DEFERRAL ITEM

Demolition of all buildings on site, including a Local Heritage (Townscape) Place and construction of a twenty-one (21) storey hotel building.

Address: 51 Pirie Street, Adelaide SA 5001

Development Application Number: 020/A131/20

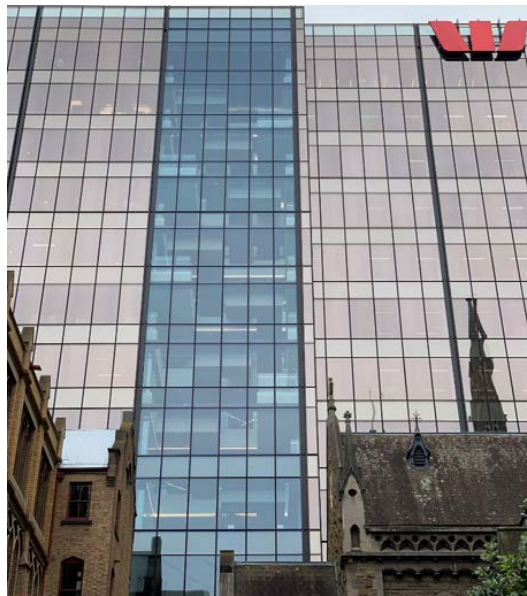
The proposed curtain wall details provided in Arup's report appear to be consistent with the design intent for a singular/monolithic appearance for the tower, including the use of blind transoms and mullions, minimal external jointing to the glazing panels and a uniform champagne tinted glass selection. As specialist facade designers and engineers, the GA defers to Arup's expertise regarding the glass selection and detailing delivering the design intent.

It is noted that a degree of visual distinction between vision glass and solid spandrels is inevitable in a curtain wall building, due to internal lighting, fitout (i.e. furniture/window furnishings) and activity occurring in the transparent conditions versus the solid wall conditions. View perspectives, sun angles and reflectivity will also affect the degree of transparency and visual quality of the facade at different times of the day and year. This is evidenced by the project examples provided in Arup's report. As such, it is accepted that the appearance of the facade may vary somewhat.

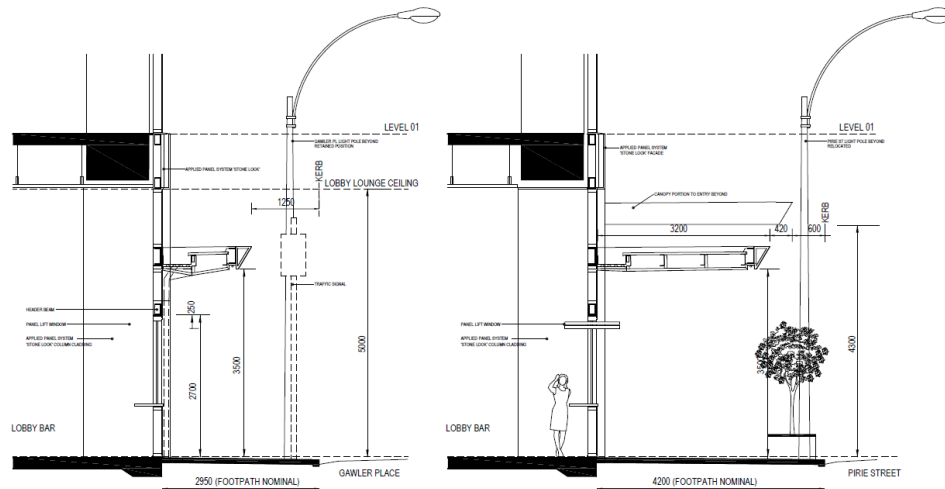
As previously mentioned, the proposed development will have glass with an external reflectivity of approximately 18%. According to ARUP the glass is expected to create sunlight reflections that would be visible to surrounding observers, including occupants of 45 Pirie Street, to the immediate west, road users and pedestrians. In the case of 45 Pirie Street, such reflections may be received during the afternoon for much of the year. However, the applicant advises that for any given location across the façade and for any reasonable occupant depth the resulting impact is considered minor. Given that 45 Pirie Street would already need to use blinds to manage direct sunlight, it is reasonable to expect blinds will also mitigate discomfort from glare induced for the small period of time expected from the proposed glazing

ARUP concludes that the comparison study confirms *that the actual visible light reflectance of the façade proposed for 51 Pirie Street is similar to, and in some cases less than other recent developments in Adelaide. Further, the level of reflectivity will not result in any unreasonable level of discomfort for surrounding building occupants or safety risks to transport users and/or pedestrians.*

The GA defers to Arup’s expertise regarding the impact of the facade reflectivity on the surrounding environment. It is also acknowledged by the GA that *the facade reflectivity and visual transmittance must be carefully balanced, based on environmental performance, NCC compliance, the envisaged architectural expression and the internal amenity of the rooms (i.e. sunlight, glare, privacy). The GA recommends careful consideration of these issues in the next stage of design development.*

Based on the information provided it is concluded that the proposed glazing will not result in unreasonable glare or discomfort or danger to pedestrians, occupants of adjacent buildings and users of vehicles (CW PDC 122). The proposal is considered to satisfy deferral motion b).

51 PIRE STREET REDEVELOPMENT - CANOPY SECTIONS
 SCAP RESPONSE ITEMS 10/08/20

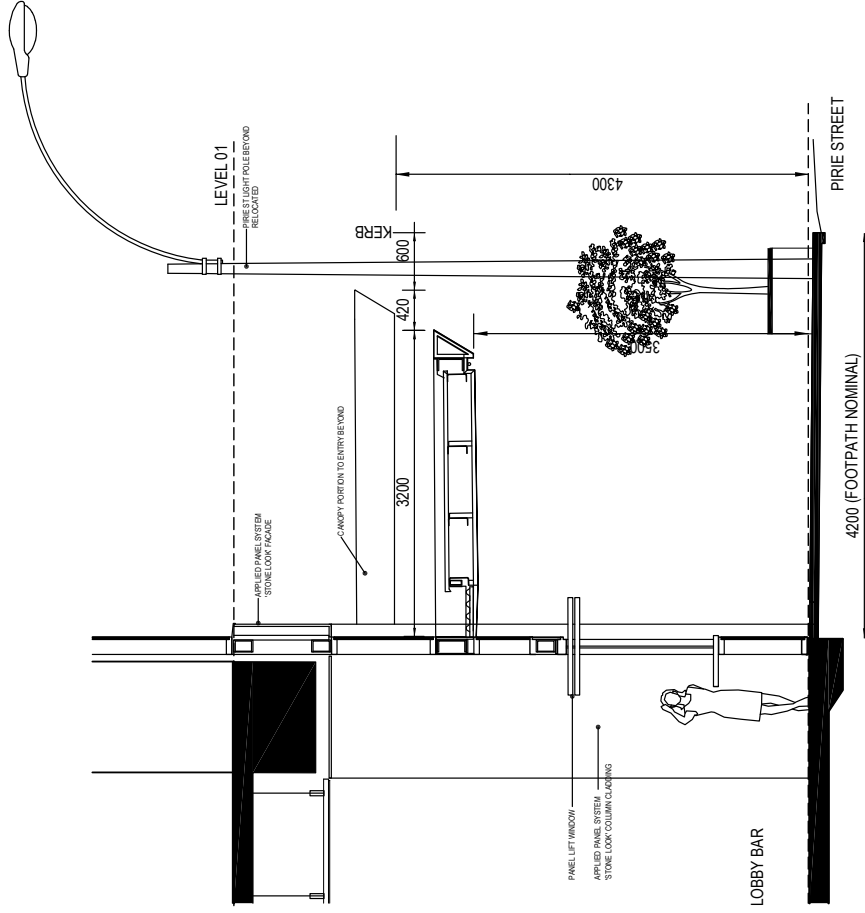
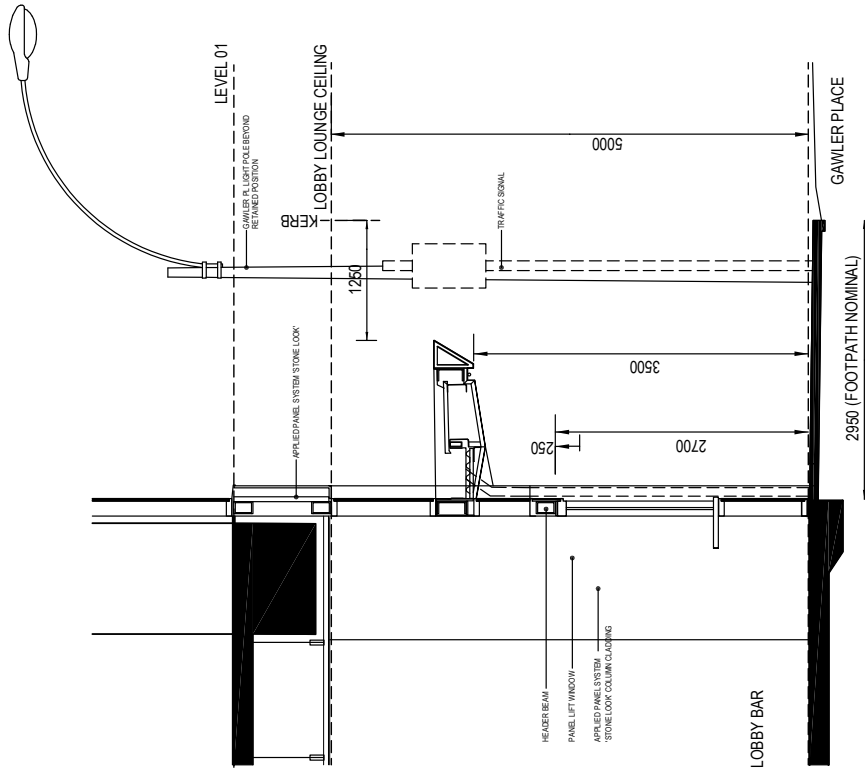
The GA provides in principle support for the amended design which includes a simplified canopy expression and improved weather protection. The GA maintains a level of reservation in relation to the relationship between the canopy and the facade composition at the base of the building. In particular, the GA questions the quality of the ceramic 'stone look' facade system (framing element and columns) and recommends further review of the design of the building base and canopy.

The proposed amendments to the canopy design and configuration are acknowledged, and in principle the GA supports the approach for a simplified canopy expression and improved weather protection. However, the GA is not yet convinced by the design of the building base and canopy. Overall, the relationship of the canopy with the facade composition, building structure, ground plane and the building interior is not yet convincing. The GA is also not convinced by the proposed ceramic 'stone look' facade system (framing element and columns) as this is not considered to be a high quality design or material outcome for the public realm. Further review of the design of the building base and canopy is recommended. The GA's support for the removal of the heritage facade is contingent on the new proposition providing a significant contribution to the streetscape and achieving a high quality design and material outcome, which has not yet been demonstrated.

The revised design and appearance of the canopy includes a reduction in the height of the canopy and for a generally more flat and simplified design with the height accentuated and widened at the main entrance, to increase pedestrian cover and amenity adjacent to the drop-off/pick-up zone. The canopy design in terms of height, kerb and street infrastructure setbacks accords with Council’s Encroachment Policy.

Notwithstanding the concerns expressed by the GA about the form and materiality of the building base, it is considered to be an acceptable planning outcome provided the materials are of satisfactory quality. A reserved matter is recommended to ensure the quality of the materials are of the required standard.

Figure 2 plan detail of typical vertical mullion, through vision zone

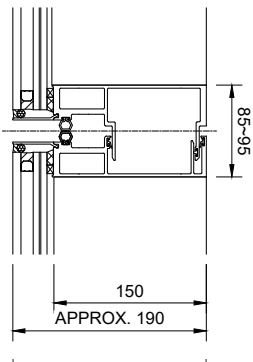
The proposed spandrel zone treatment for the 51 Pirie Street development utilises a 'shadow box' construction method. Although the vision and spandrel glass are separated by a transom, the same glass will be used in both and vision and spandrel zones, which helps better render the spandrel and vision zones as one uniform unit (Figure 1).

Figures 2 to 5 depict the proposed mullion details (vision zone and spandrel zone), while Figures 6 on the next page depicts the shadow box detail proposed for the development, with Figure 7 providing a visual reference for how this will ultimately appear to the external observer. Page 12 contain examples of two precedent buildings with spandrel zones that appear uniform with the window glazing as a result of the shadow box method for visual reference:
